Conceptual Model for the High Plains Aquifer GAM

Stakeholder Advisory Forum #2
Lubbock, TX

May 14, 2014

Stakeholder Meeting #2, Amarillo, May 12, 2014

Pre-development Water Levels

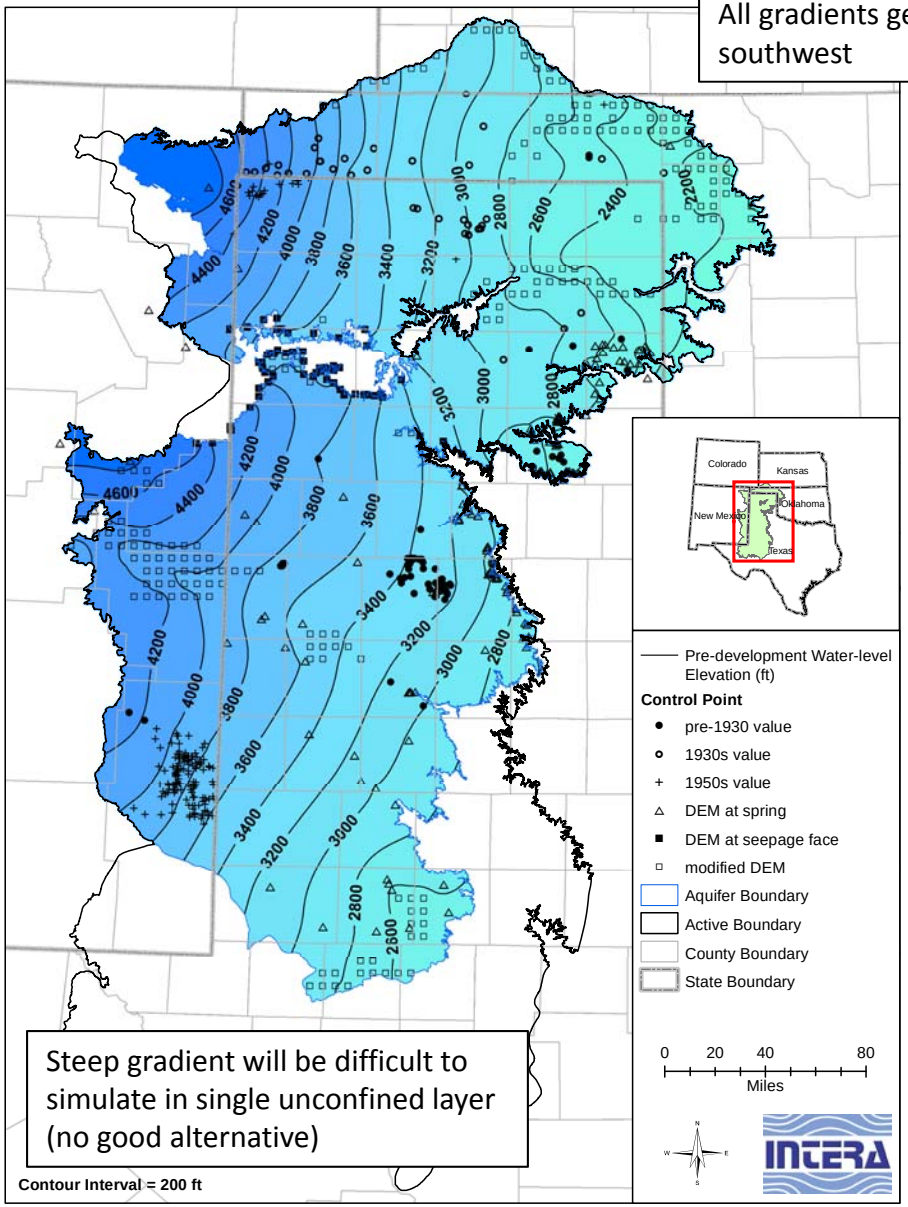
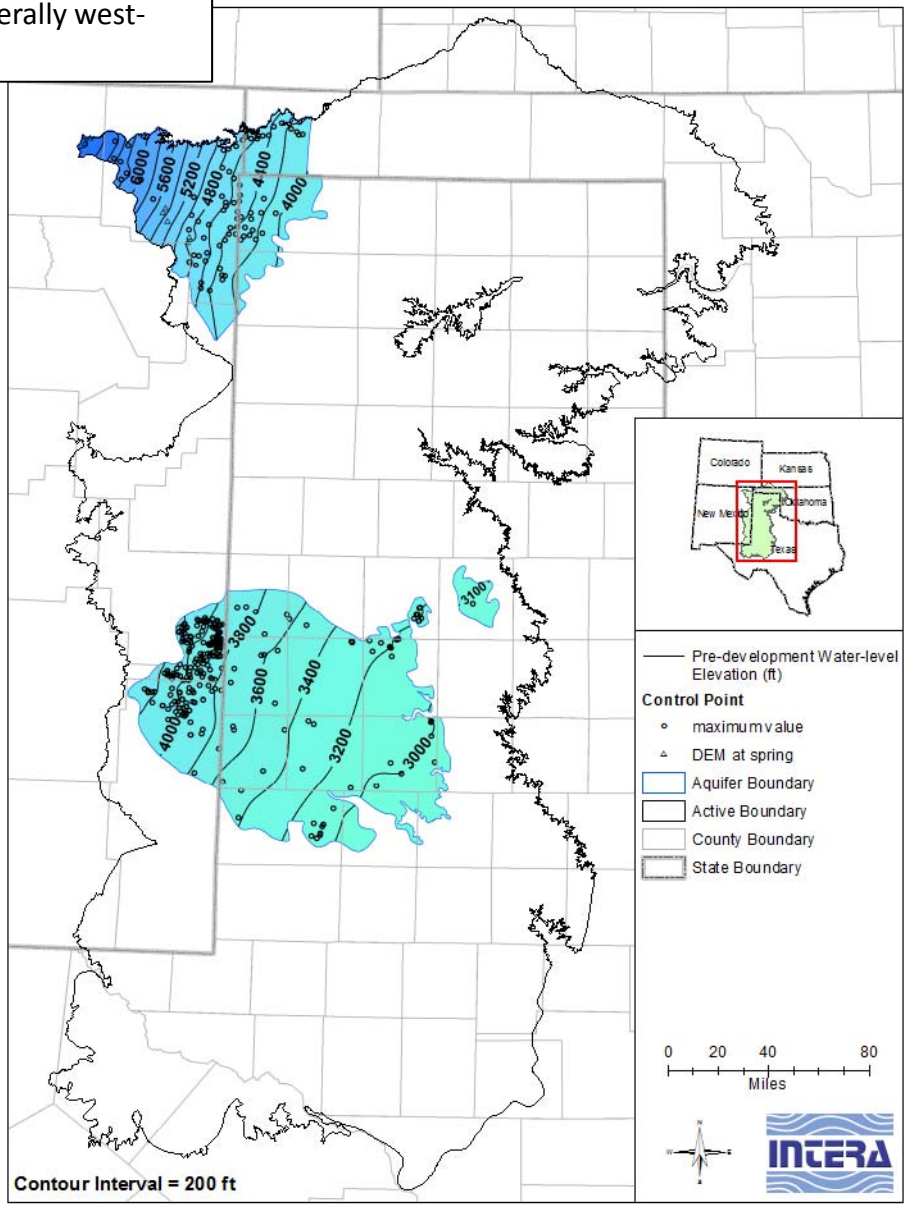
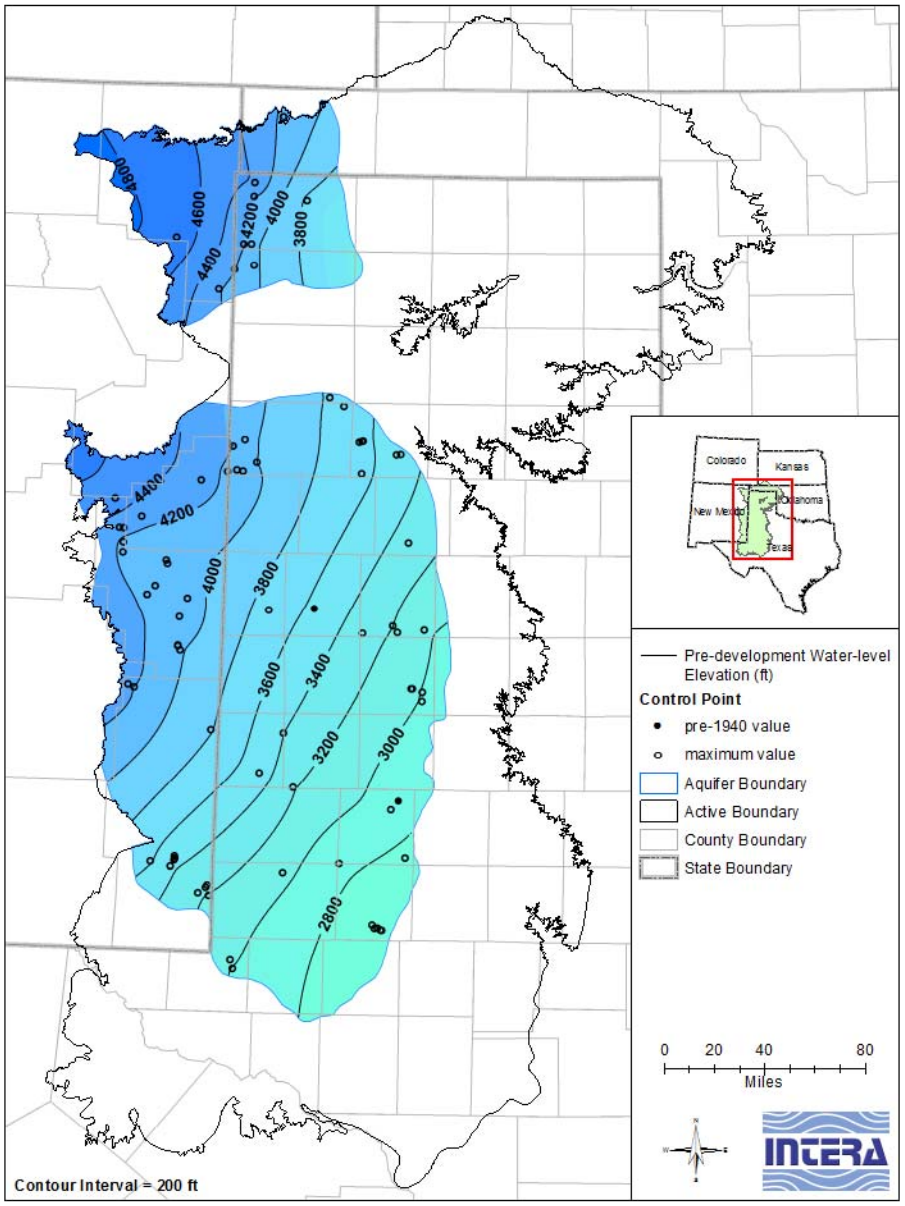
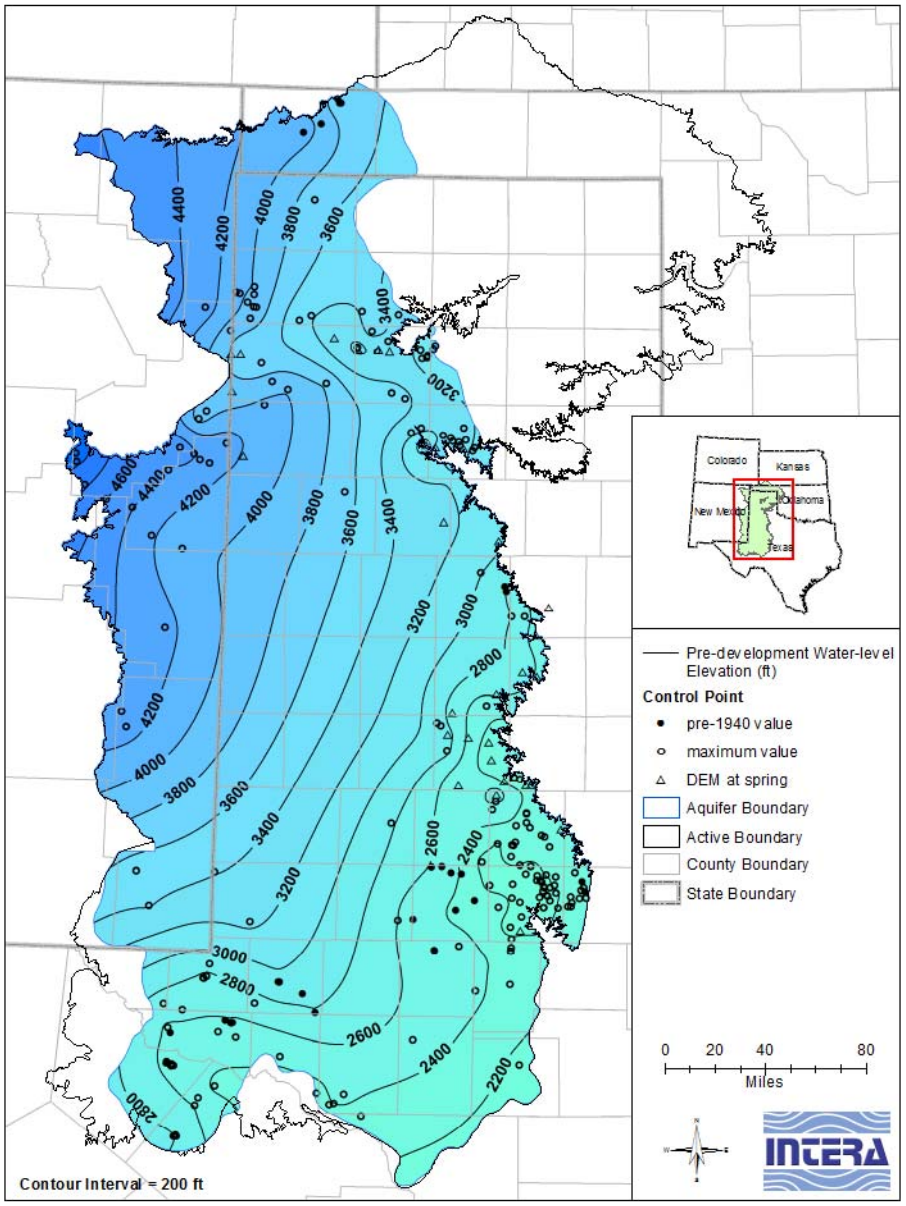
10. Please adjust pre-development and post-development legends so that the bins are the same color.
11. Comment on springs: In Dallam County, Buffalo Springs may eminate from the Rita Blanca instead of Ogallala/Dockum.
